**PRELIMINARY DRAINAGE REPORT**  
for  
**THE COMMONS AT FALCON FIELD**

**June 29, 2023**

**PCD FILE NO. SP-232 ●**

**DR2**

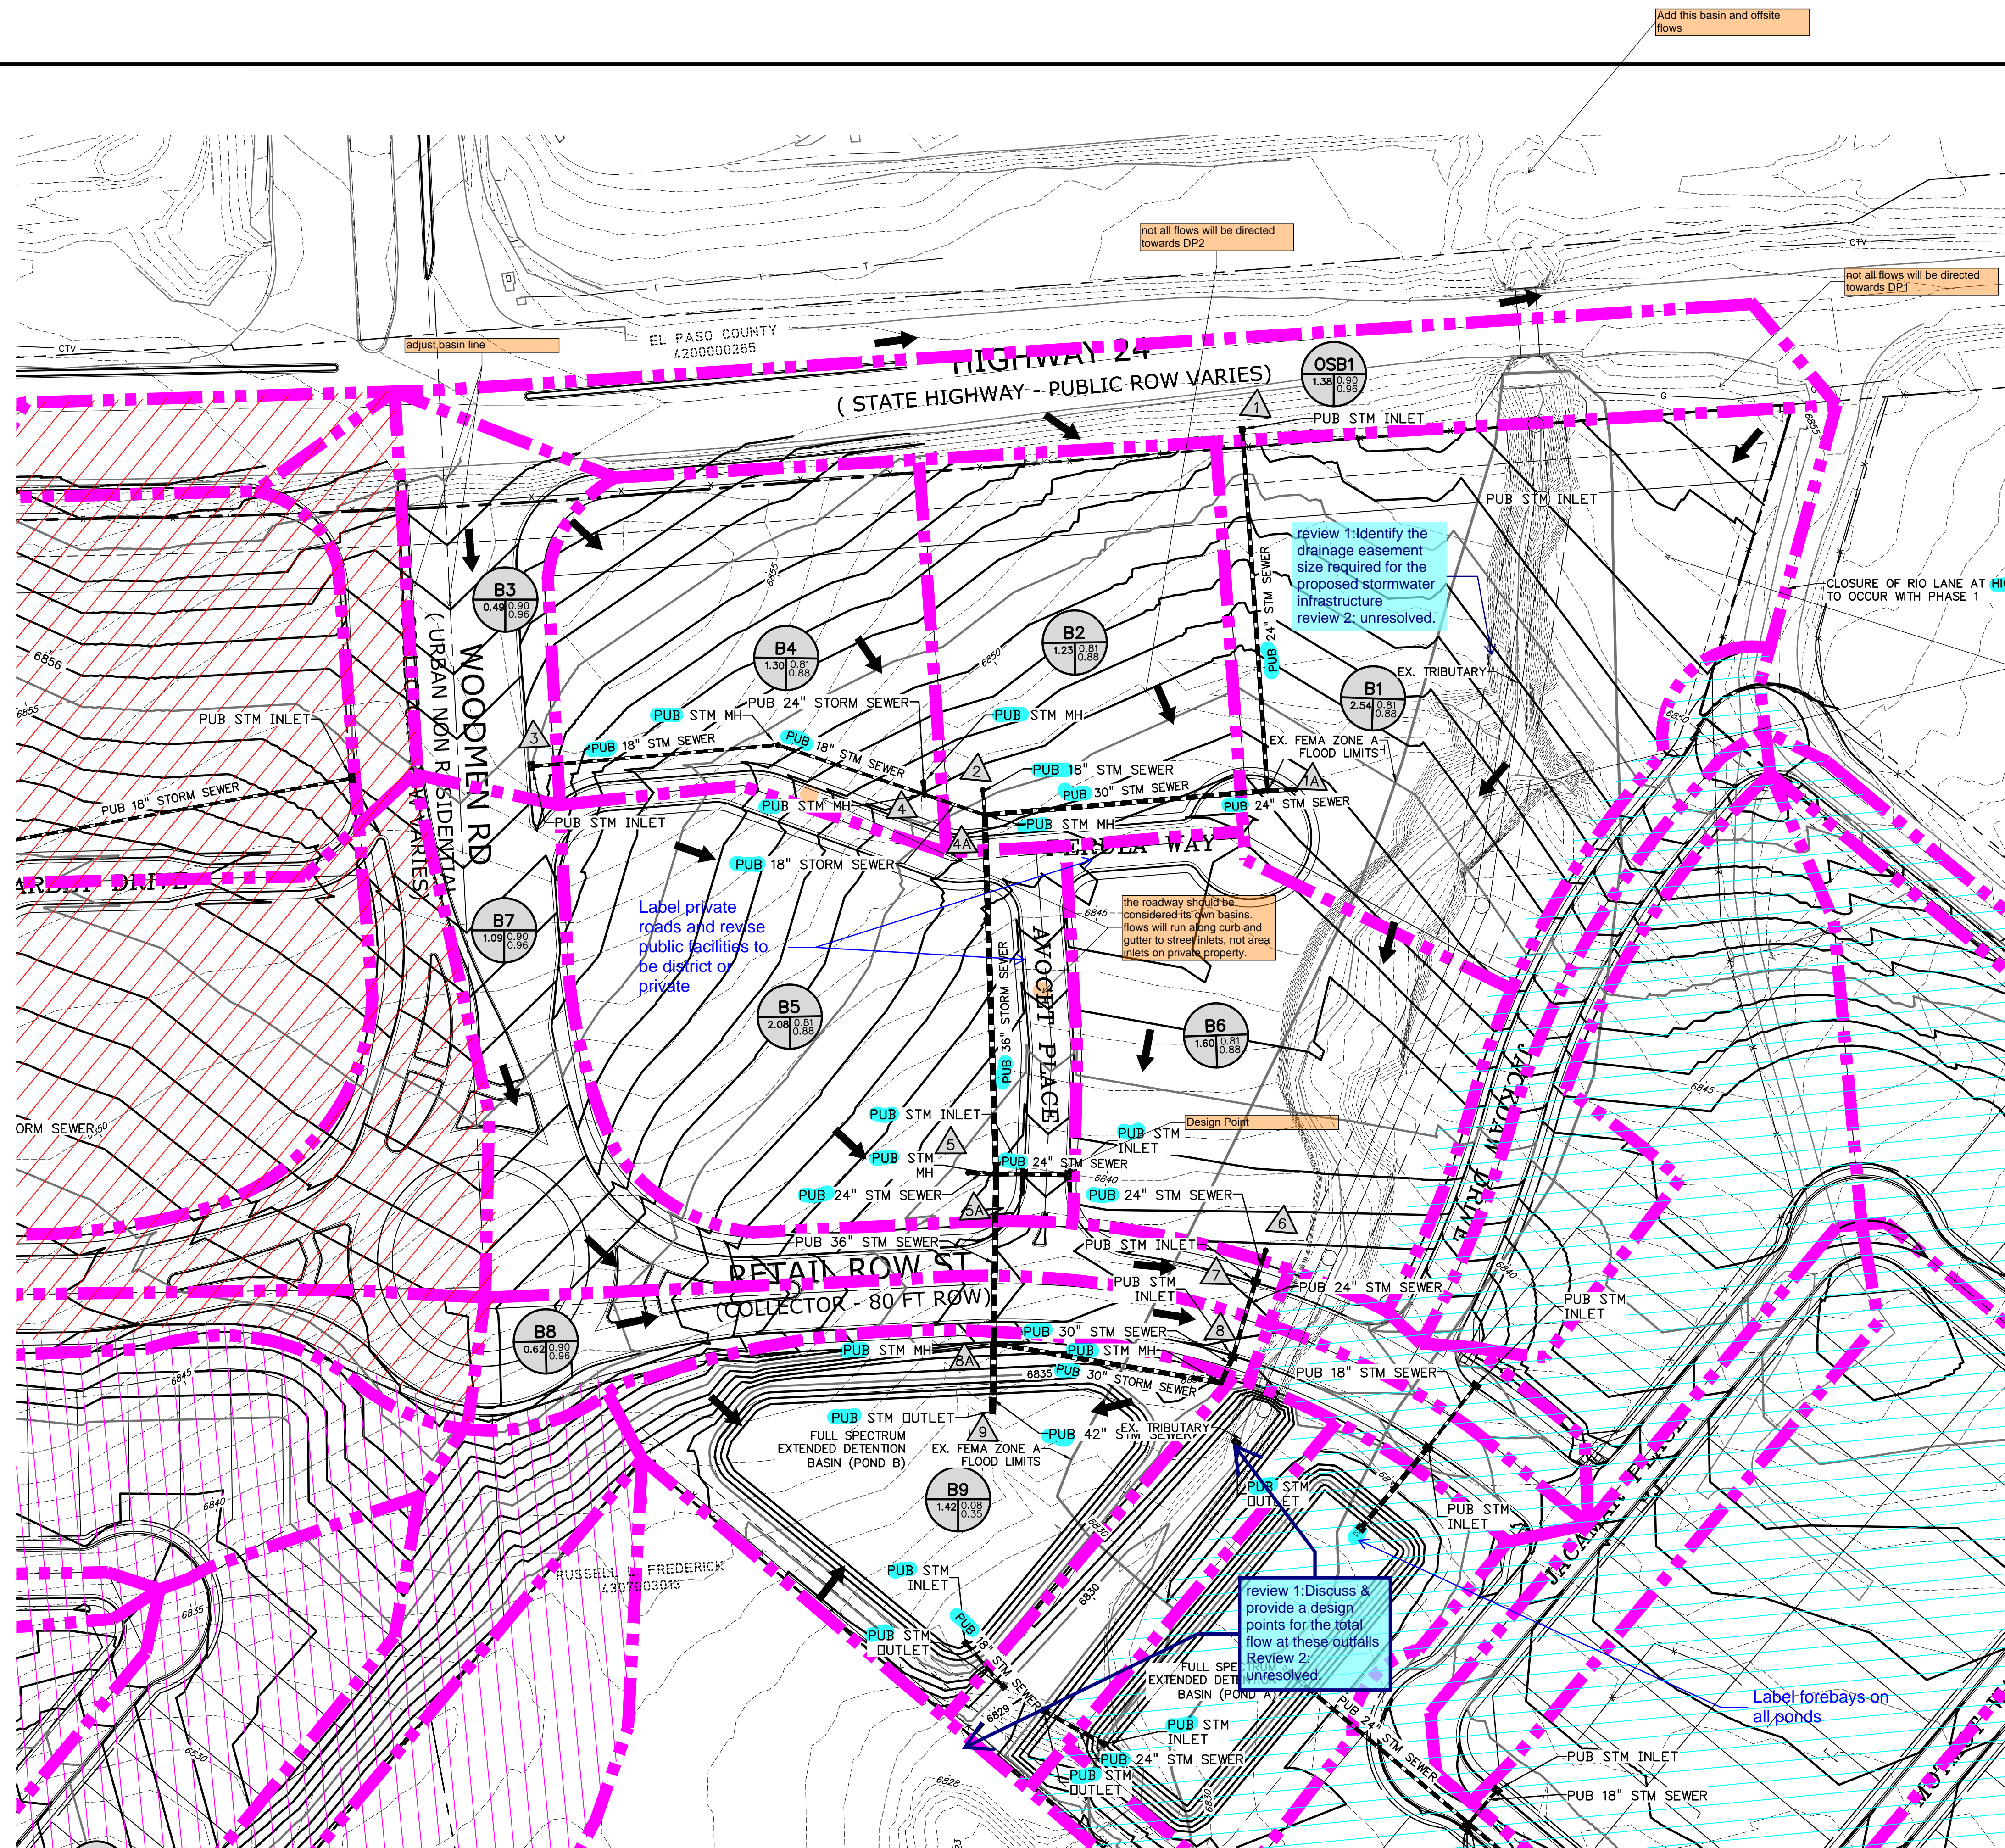
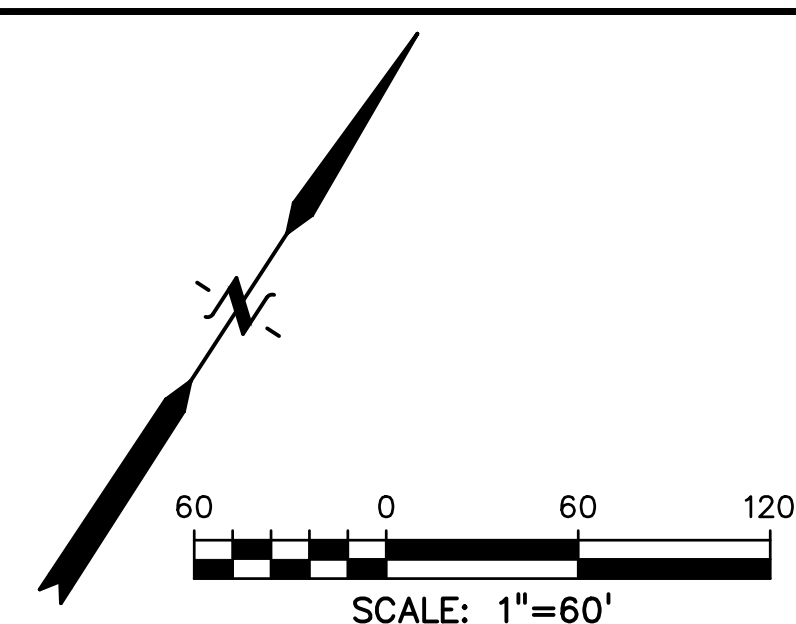
add A16

**DR5**

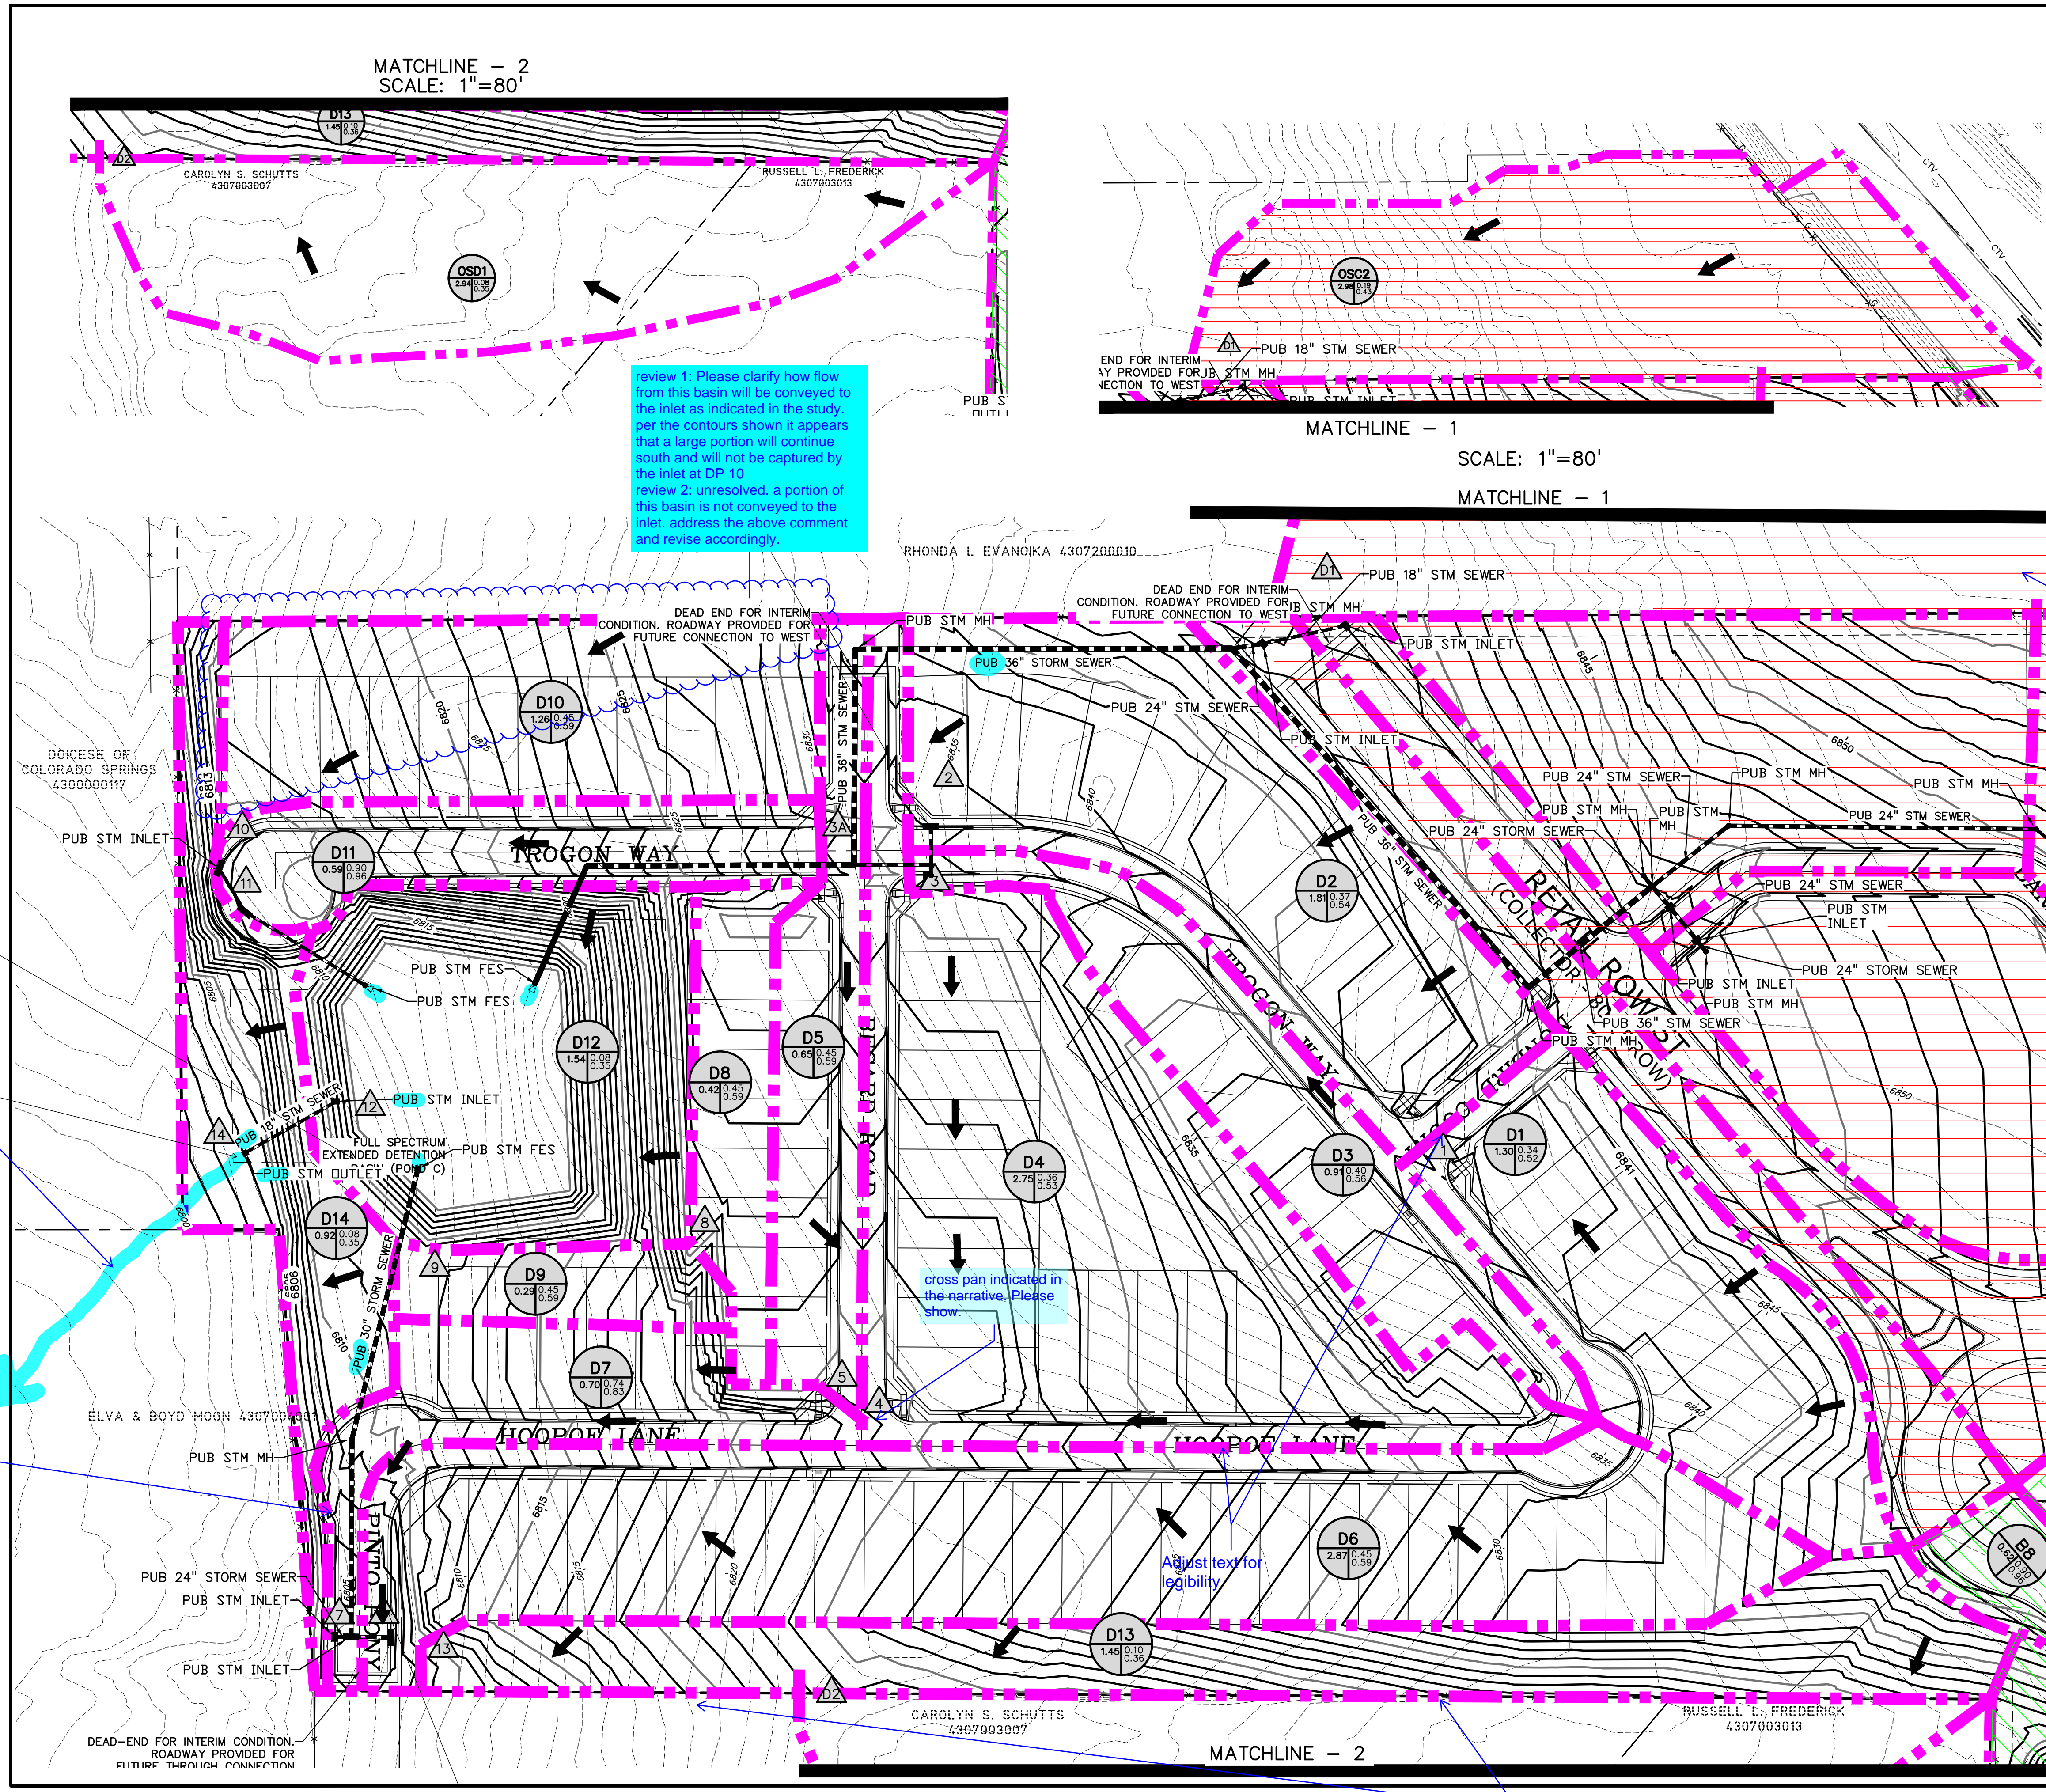
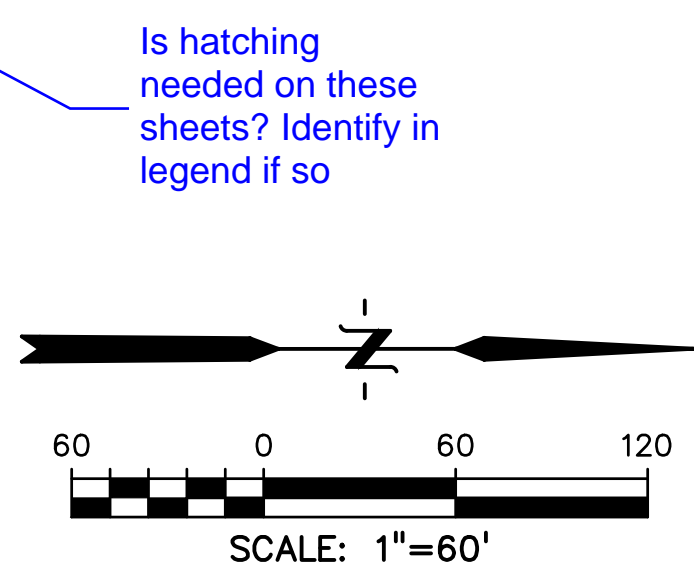
review 1: Please clarify how flow from this basin will be conveyed to the inlet as indicated in the study, per the contours shown it appears that a large portion will continue south and will not be captured by the inlet at DP 10  
 review 2: unresolved, a portion of this basin is not conveyed to the inlet, address the above comment and revise accordingly.

cross pan indicated in the narrative, please show.

show all necessary downstream conveyances and easements to an adequate suitable outfall

Provide design for turnaround until road is connected to the east
